Certificate of Appropriateness

Property 2034 N. 1ST ST. **Brewers Hill Historic District**
Description of work Tear off existing roofing shingles and install new GAF Timberline Natural Shadow shingles in weathered wood color. Existing gutters will be temporarily removed and then re-installed at completion. Existing concrete block chimney will be removed and the roof patch in an appropriate manner.
Date issued 9/8/2014 PTS ID 97477 COA, new roof

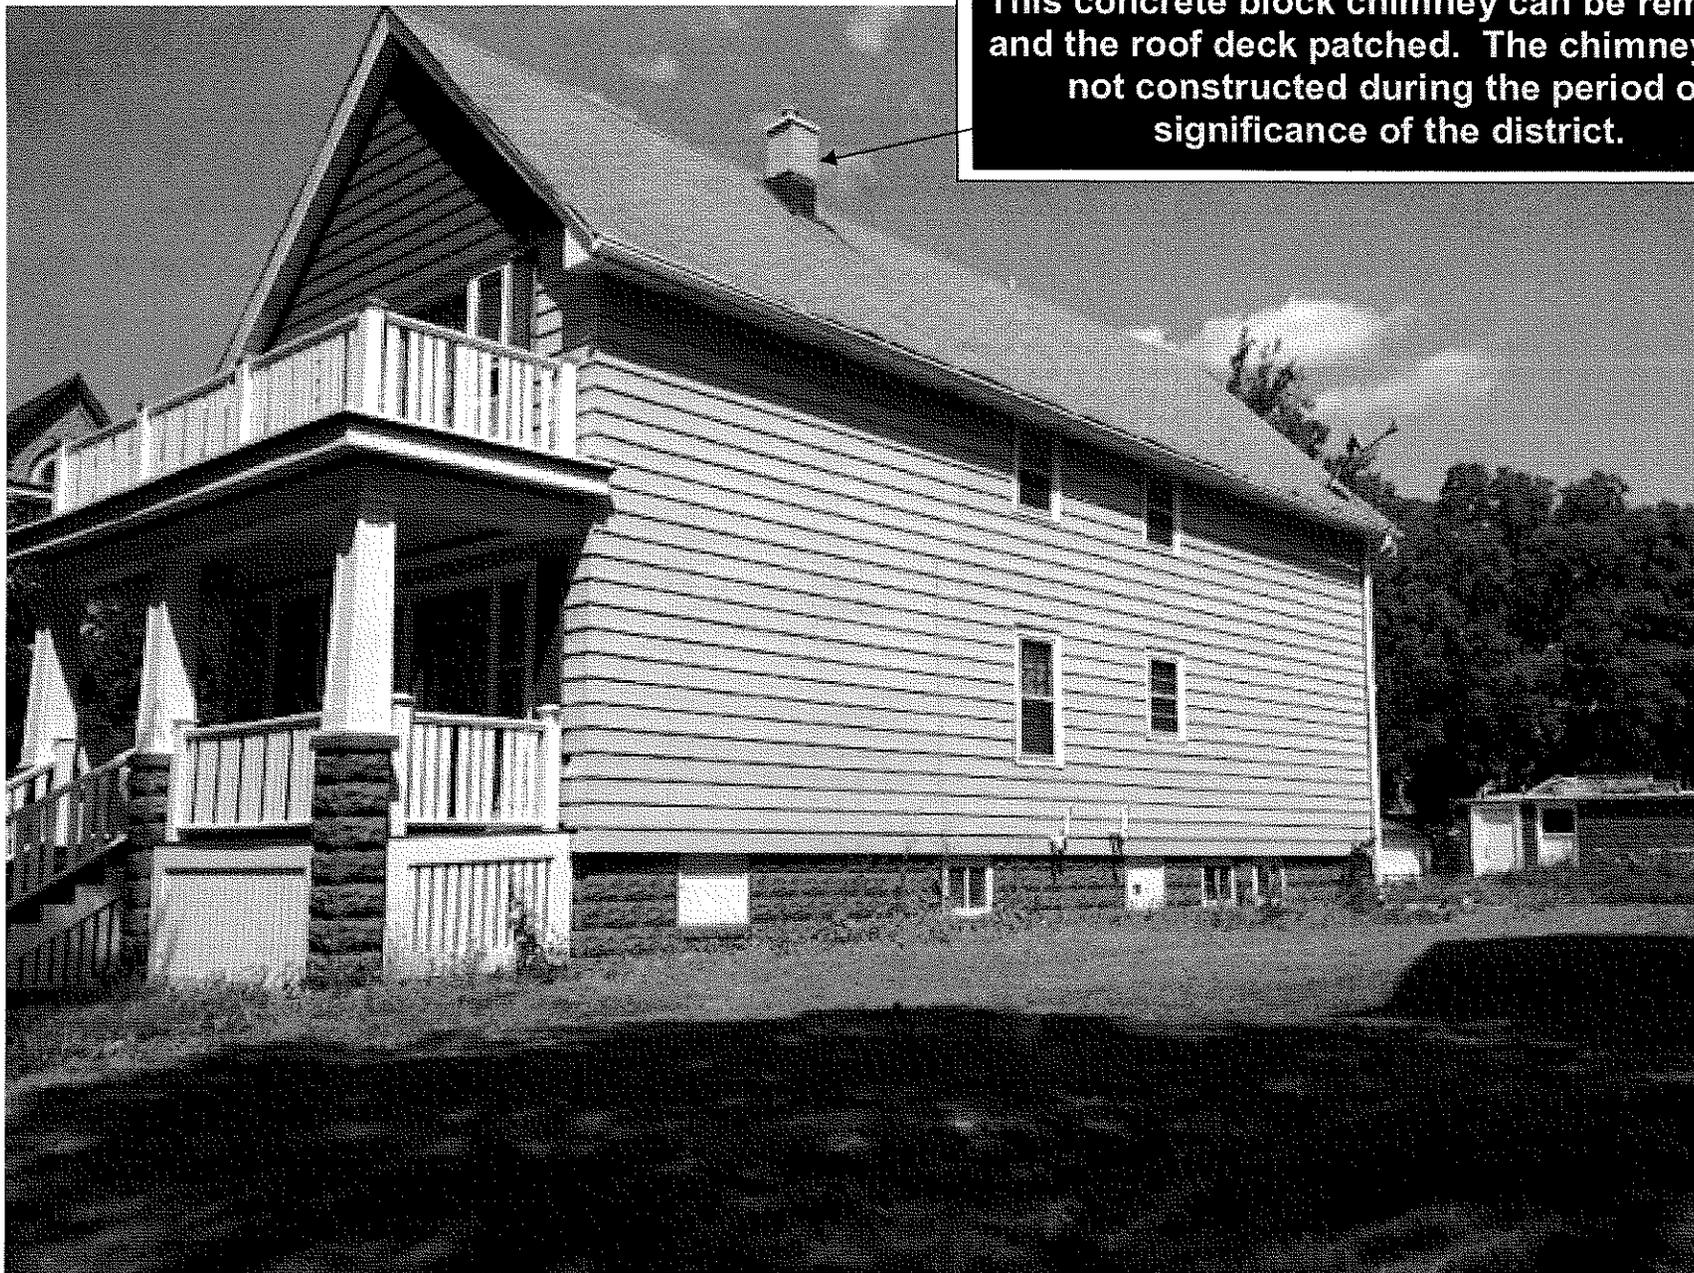
This concrete block chimney can be removed and the roof deck patched. The chimney was not constructed during the period of significance of the district.

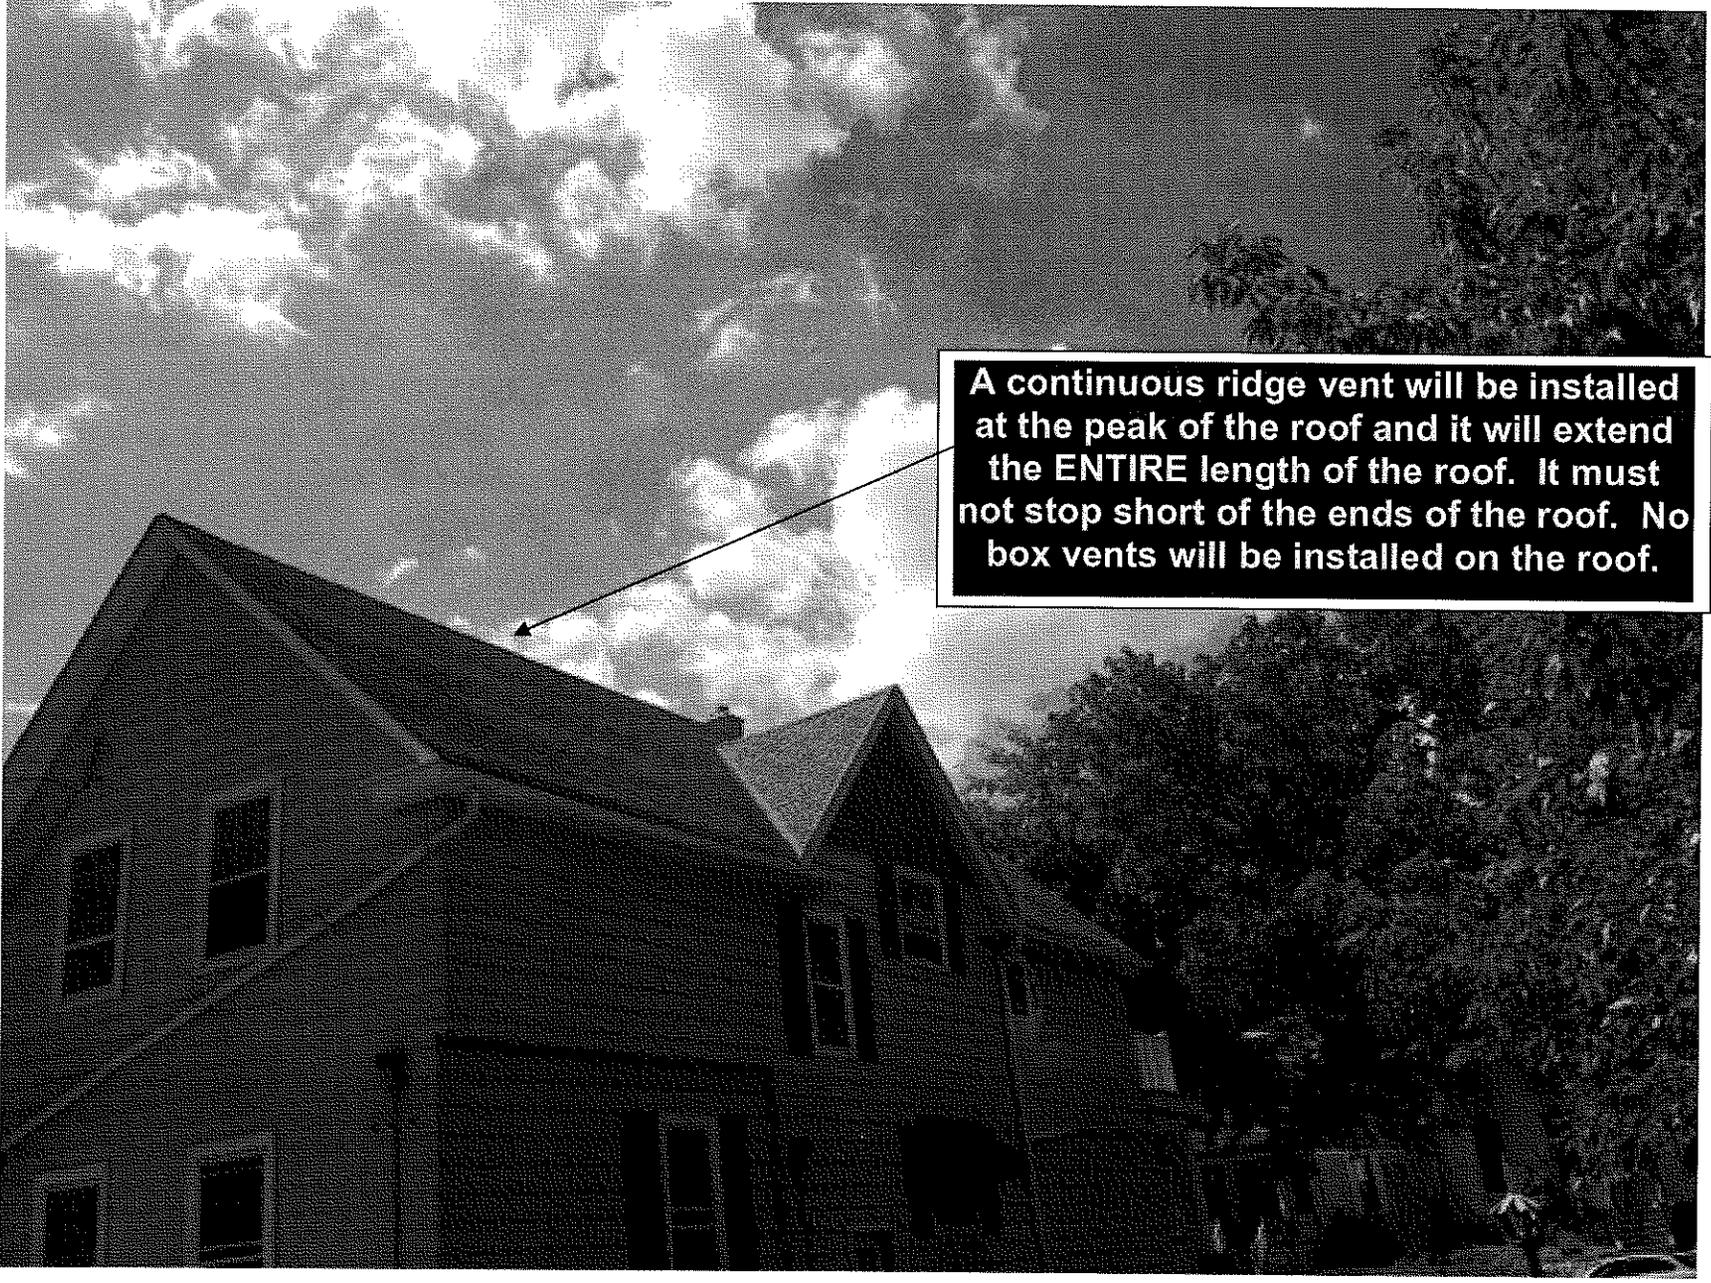
A continuous ridge vent will be installed at the peak of the roof and it will extend the ENTIRE length of the roof. It must not stop short of the ends of the roof. No box vents will be installed on the roof.
